mercruiser STERN DRIVES & INBOARDS

parts bulletin

No. 95-2

V6 & V8 Replacement Cylinder Heads

a - Push Rod Hole: Slot=Keeps Push Rod Aligned.
Drilled Hole=Must Use “Self Aligning” Rocker Arm.
b - “Non Self Aligning” Rocker Arm.
c - “Self Aligning” Rocker Arm.

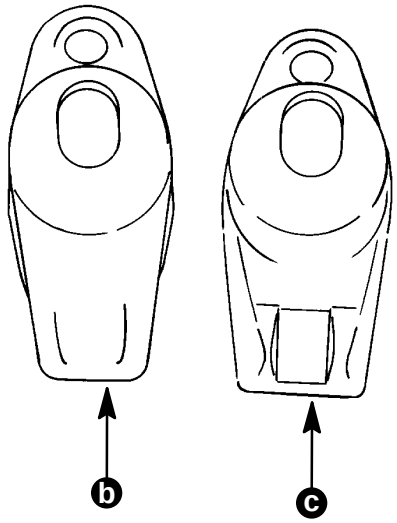
Before ordering a replacement cylinder head for any of these engines, look at the hole in the cylinder head that the push rods come through. Also look at the type of rocker arms that came off. If the rocker arms are not the “Self Aligning” type rocker arms, all new rocker arms must be ordered also. All replacement heads have a hole for the push rod. If “Self Aligning” type of rocker arms are not used with these new heads, the rocker arm will not stay on the push rod.
